Determination 2008/81

Safety barrier to a deck located adjacent to a retaining wall at Oraka Beach Road, Mahia

Figure 1: Section showing deck and top of the bank

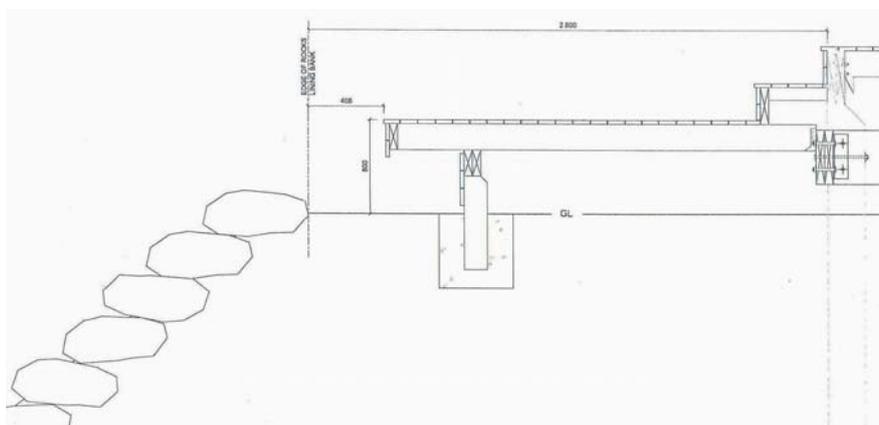
7.1.1 As stated in Clause F.4.3.1, a safety barrier is required where people could fall 1 metre or more from the floor of a building. In this case, the floor of the building is the top level of the deck, which is 500mm above the finished level of the building platform. I also note also that the minimum width of level ground from the edge of the deck to the top of the retaining wall appears to be in the range of 600mm to 800mm and I consider that this dimension is crucial to my decision.

7.1.2 The authority has concerns because the ground level suddenly falls away at a point approximately 1 metre on average from the deck edge. The authority believes there is danger that people who are using the deck and fall off it, would continue to fall down the face of the retaining wall. The authority has referred to SNZ HB 8630, which uses a formula that adjusts the fall height in accordance with an impact surface adjustment value. This formula has the effect of extending the fall height factor some distance away from the face of the structure from which a potential fall could occur.

- 7.1.14 This acceptance, together with my observations set out in paragraphs 7.1.7 to 7.1.9, leads me to believe that the 600 to 800mm dimension from the edge of the deck to the top of the retaining wall is insufficient for the deck to comply with Clause F4.3.1, unless it is provided with an adequate barrier. In addition, I note that the adjoining rock retaining wall bank is of such a steepness that someone could tumble down and injure themselves. Accordingly, the deck needs to be far enough away from the wall to prevent anyone falling off it from tumbling down the wall. I therefore consider my decision to be in accord with the objective of Clause F4, which requires people to be safeguarded from injury caused by falling.

- 7.1.17 The designer has noted that one solution to this matter would be to shift the deck back from the edge to provide a 900mm landing area between the deck edge and the bank edge. However, I consider that, in order to provide protection against falling down a steep bank, the height of a deck above the ground must be taken into consideration when establishing the required distance from the deck to the top of the bank. As the height in this case is 500mm, I consider that a landing area of 1200mm to the outer face of the stone wall would provide adequate protection.

- 8.1 In accordance with section 188 I hereby determine that the deck:
1. requires a safety barrier in order to comply the requirements of the Building Code, and
 2. requires a building consent.

Figure 2: Plan of house showing deck and bank

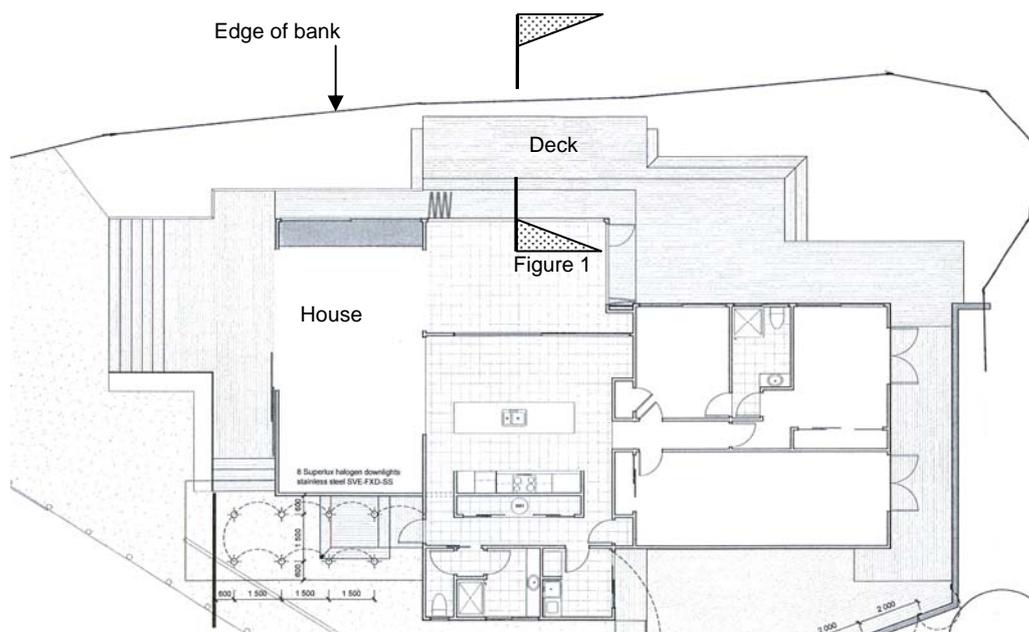
- 2.1 The building work that is the subject of this determination is a deck (“the deck”) 6.9 metres long x 2.4 metres wide that is proposed to be constructed at the north elevation of a house. The deck is timber framed and its top is 500mm above the ground. The deck was originally part of a consent application that involved the construction of a veranda and a roof. The plan of the house and deck is shown in Figure 2. The section through the deck and adjacent bank is shown in Figure 1.
- 2.2 From a minimum of 600mm (and an average of 1 metre) from the northern edge of the deck, the ground level suddenly slopes away from the building platform down the face of a retaining wall composed of uneven layers of rocks and boulders. The retaining wall is approximately 2.5 to 3 metres high below the deck location and is set to an angle of approximately 45 degrees.
